BendPak Technical Service Bulletin

HDS-14 and HD-14T – Cylinder Flange Arm Slides Replacement

BendPak TSB 107-012023

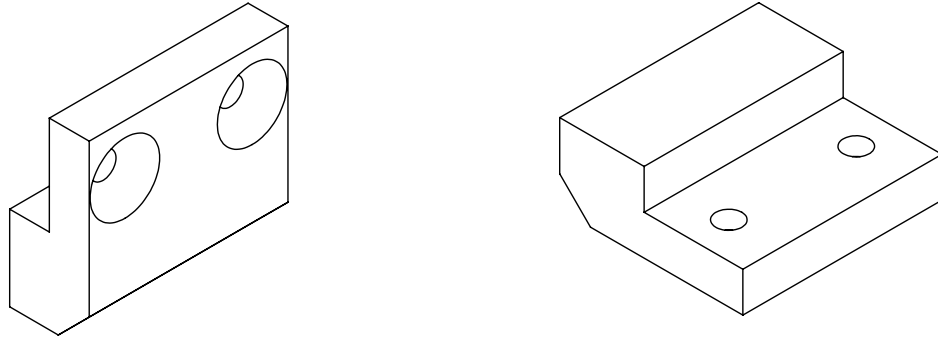
2. Remove and retain the four M6 Phillips flat head machine screws, flat washers, and hex nuts securing both Slides.

3. Discard the two Slides (5716006) just removed.

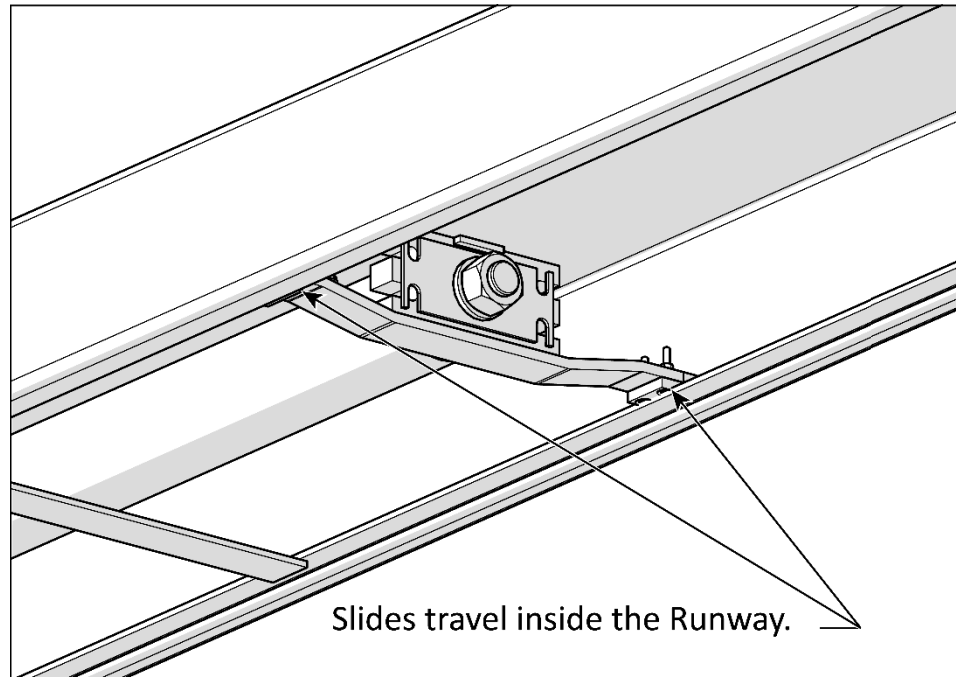
4. Install the replacement Slides (5716092) accompanying this TSB using the fasteners removed in step 2.

5. Verify the Flange and replacement Slides travel inside the Powerside runway without obstruction.
